PRODUCT / PROCESS CHANGE NOTIFICATION

1.1 Company		STMicroelectronics International N.V
1.2 PCN No.		MDG/21/12675
1.3 Title of PCN		ST Muar (Malaysia) LQFP7x7 32L line transfer for STM8S/L listed products
1.4 Product Category		STM8L15x 32K STM8S20x 128K STM8S20x 32K STM8S20x 8K
1.5 Issue date		2021-03-25

**PRODUCT/PROCESS
CHANGE NOTIFICATION
PCN12675– Additional information**

**ST Muar (Malaysia) LQFP7x7 32L line transfer
for STM8S/L products**

How can the change be seen?

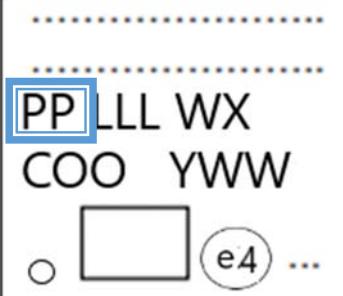
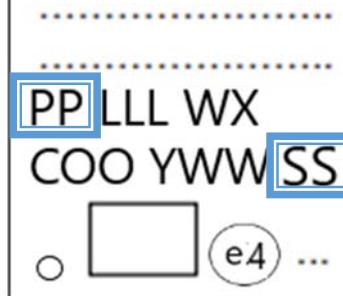
Pin1 identifier can change in terms of form and positioning.

Marking position and size could be different upon assembly site, without any loss of information.

No Digit	With 2 Digits Enhanced Tracability (SS) marking
Marking example

PP code indicates the Assembly traceability plant code.

PP code	Assembly Line - Fab
GQ	Stats ChipPAC Jiangyin JSCC (China)
99	ST Muar (Malaysia)
